### Proposed Revisions to a Standard Plans Index

Index Number: 400-090  
Sheet Number (s): 1  
Index Title: Approach Slabs (30ft) (Flexible Pavement Approaches)

**Summary of the changes:**

LAST REVISION 11/01/22	DESCRIPTION:		FY 2023-24 STANDARD PLANS	APPROACH SLABS (30 FT.) (FLEXIBLE PAVEMENT APPROACHES)	INDEX	SHEET
					400-090	1 of 2

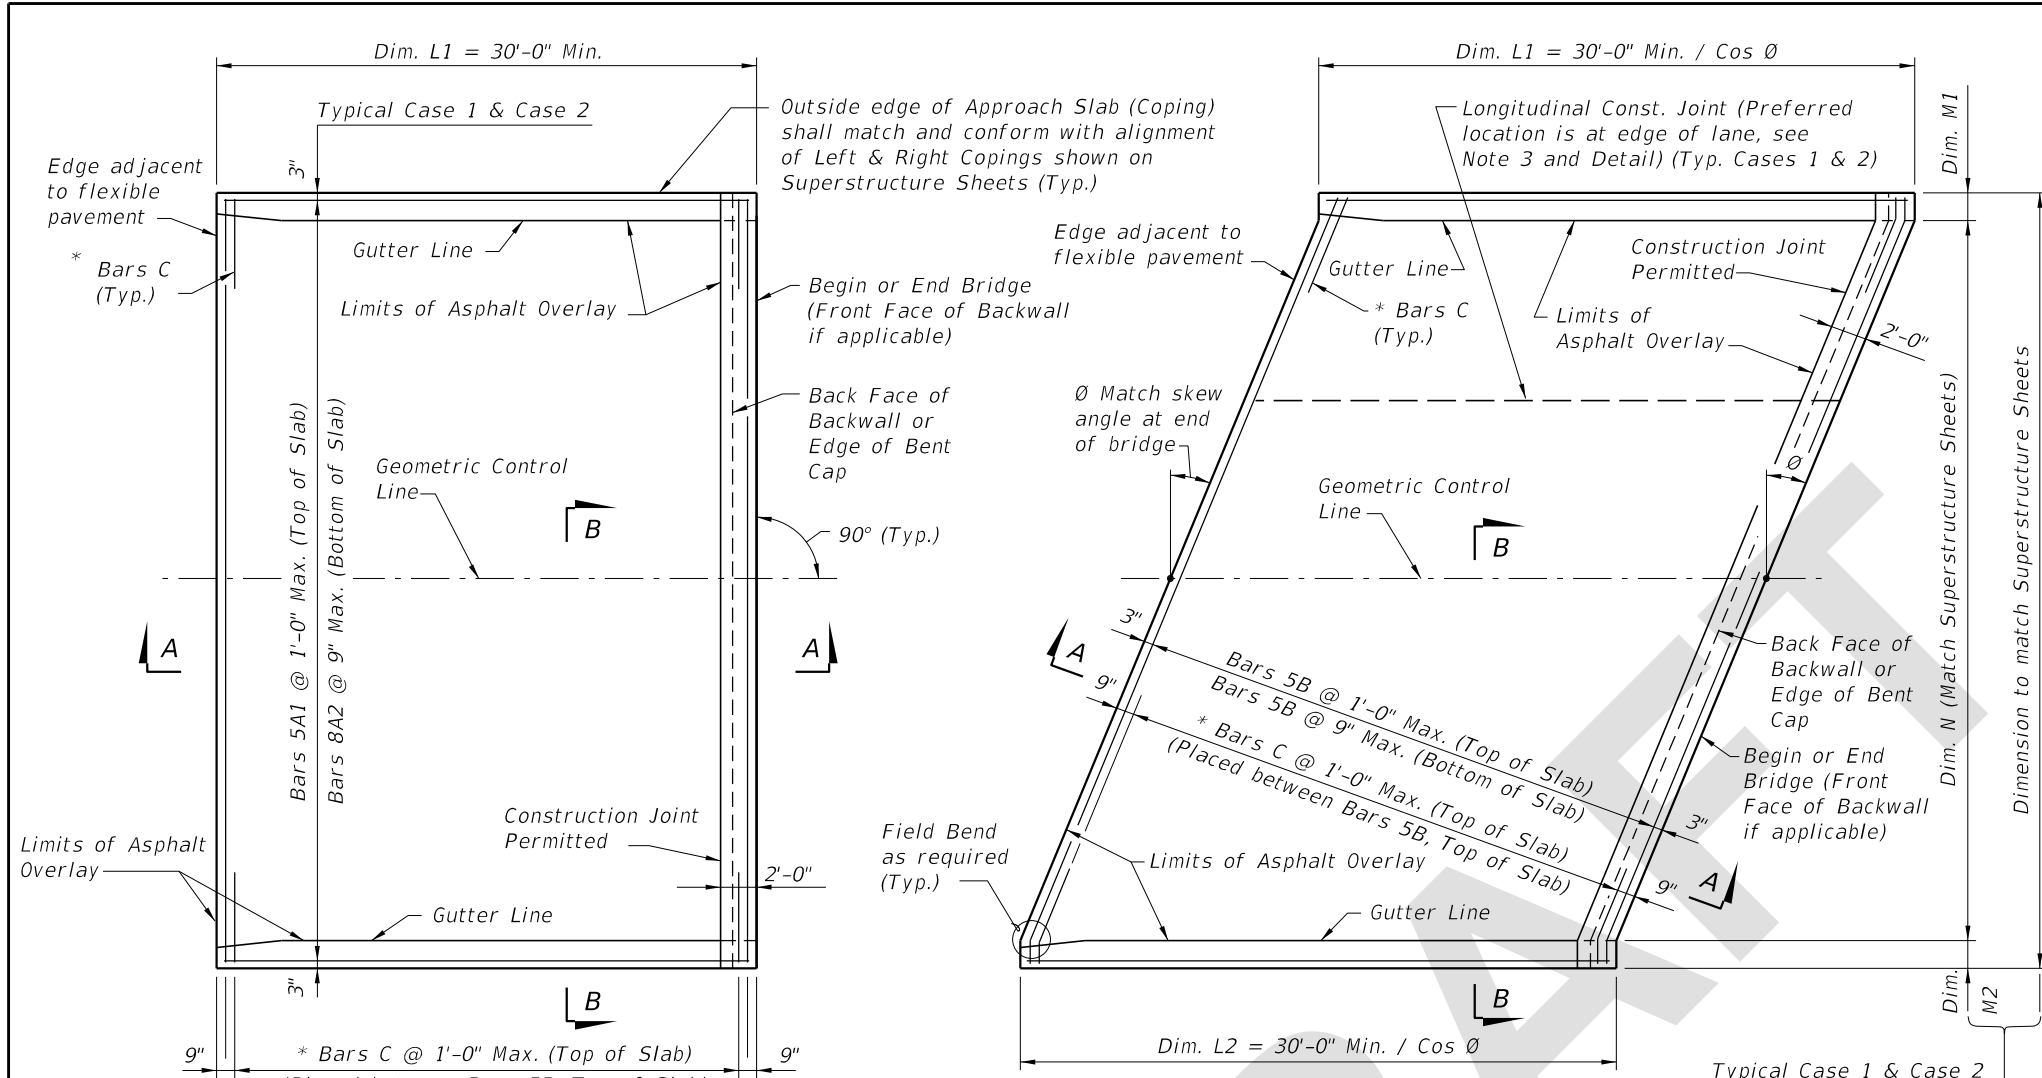
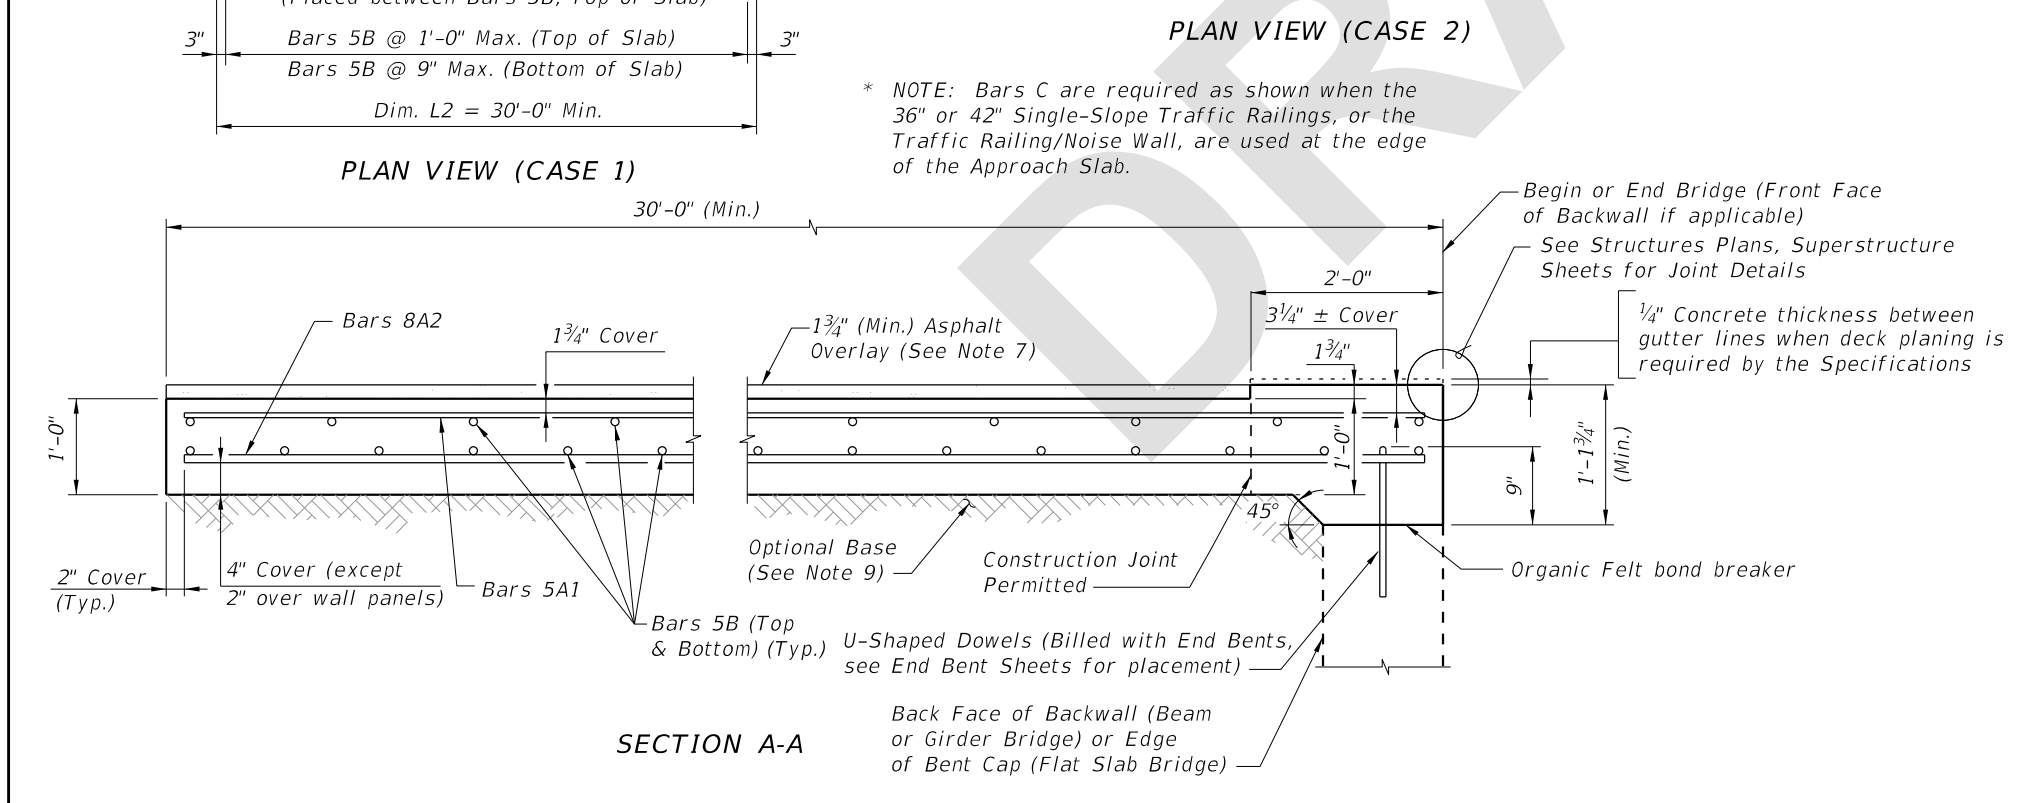
Broke note 9 into 2 notes.
